***Special Use Permit #2023-00076***  
***404-A E. Alexandria Ave – Substandard Lot without Street Frontage Development***

# Special Use Permit #2023-00076 404A East Alexandria Avenue

Figure 8 – Average finished grade calculation

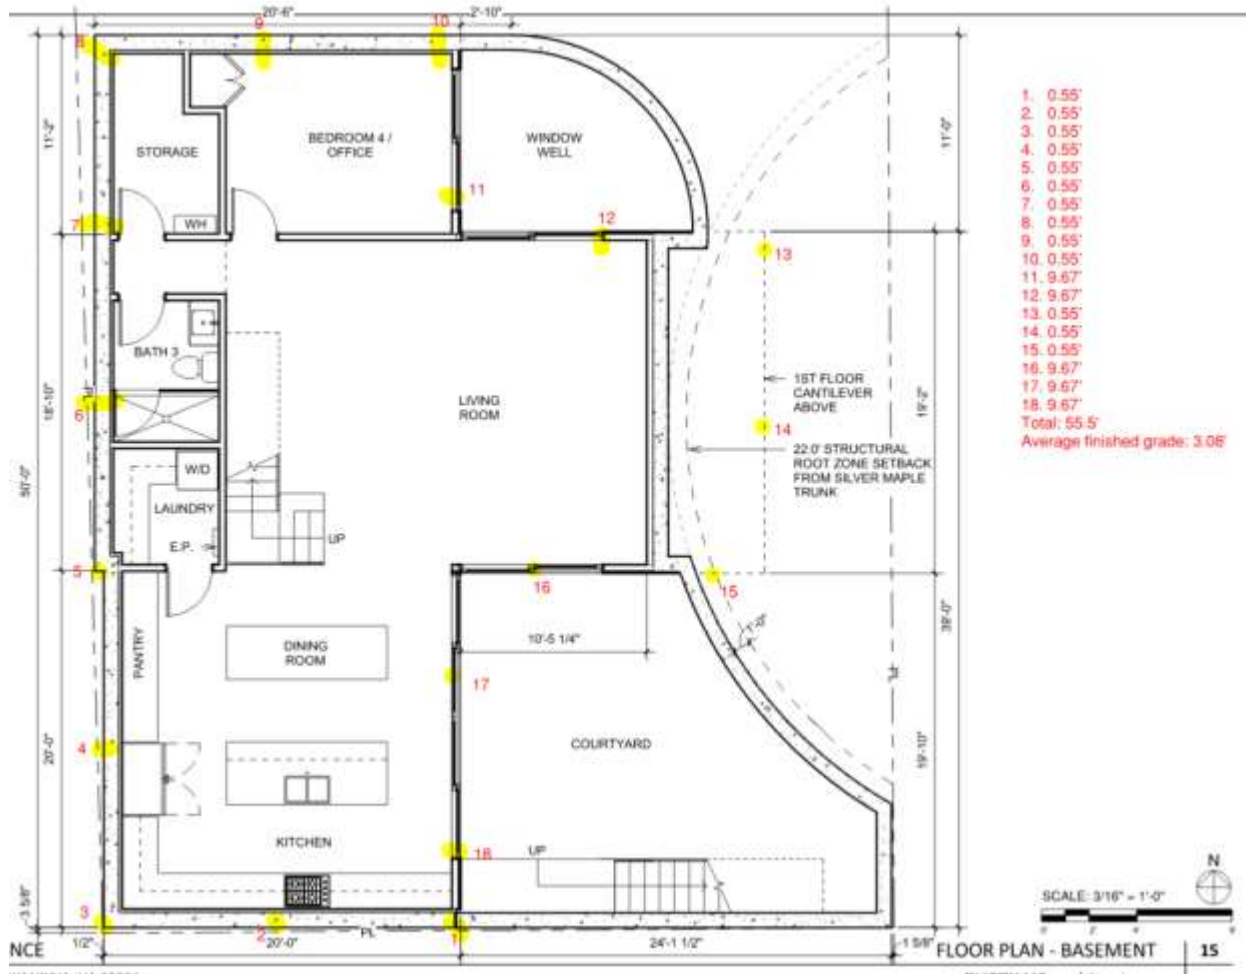
Per Section 2-120, a basement shall only count as floor area where the average finished grade is four feet or more below the bottom of first floor construction. Per Section 2-150.2, average finished grade is calculated by averaging the surface level elevations at 10-foot intervals around the perimeter of the proposed building, which includes the basement. Figure 8 shows the points used to calculate average finished grade from the bottom of the first floor.

The project as designed is dependent on the basement square footage being excluded from the FAR calculation, and the assumption that because the basement does not count as FAR, the ADU is considered detached even though there are continuous interior spaces between the primary dwelling and the ADU. The LUC questioned whether the basement would comply for being below the average grade calculation. In addition, the setbacks do
